BGA ENGINEERING NEWS

Number 9, November 2001

Figure #1 (Ref.: fig 16– Parts Catalog)

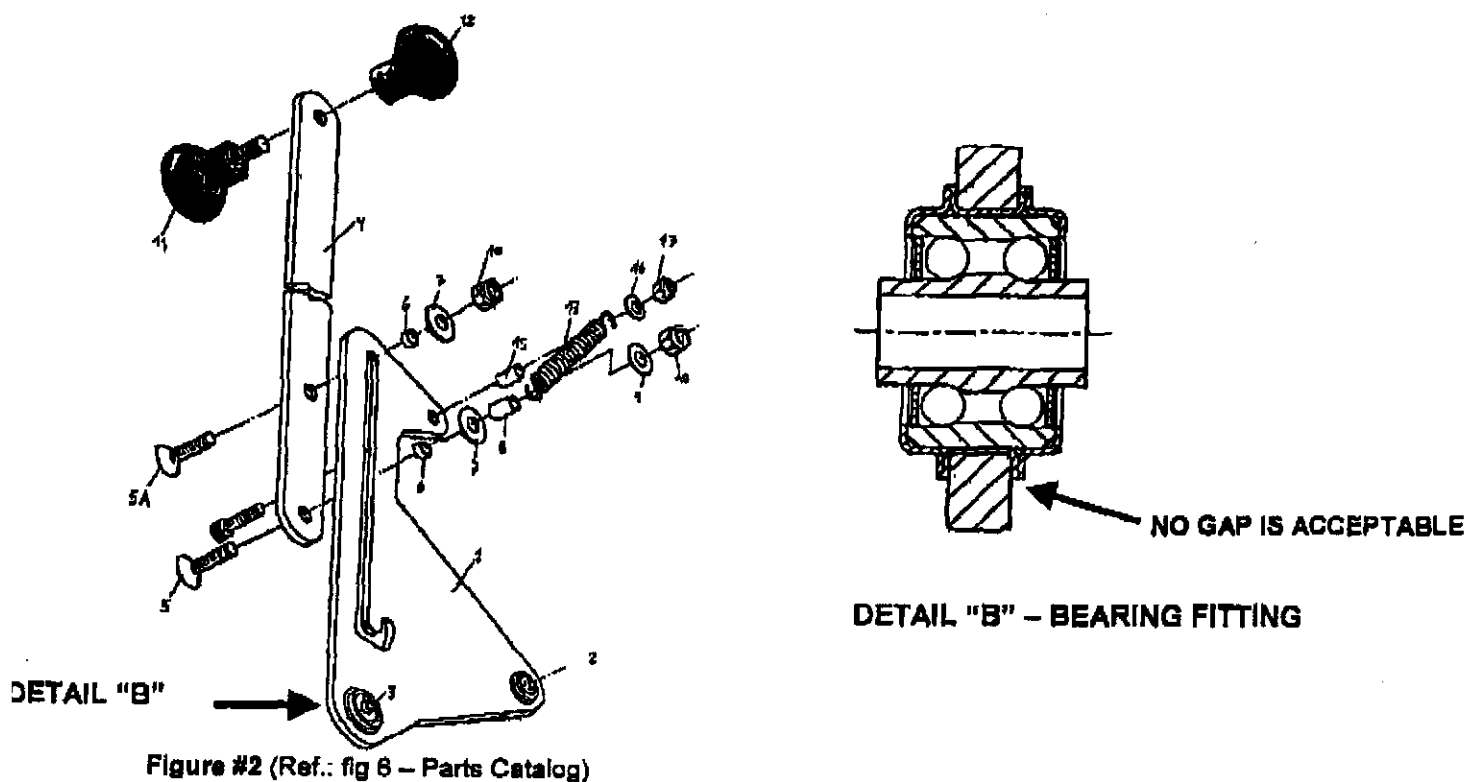
2.4 Push the control stick (elevator driving) slowly forward and check if the gap between landing gear lever (in retracted and caged position) and nut that fix the terminal rod of elevator driving is about 3 to 5 mm in accordance with detail "A" of figure #1.

2.5 Check if the gap between screw head and the trim cable cap is about 3 to 5 mm in accordance with detail "A" of figure #1.
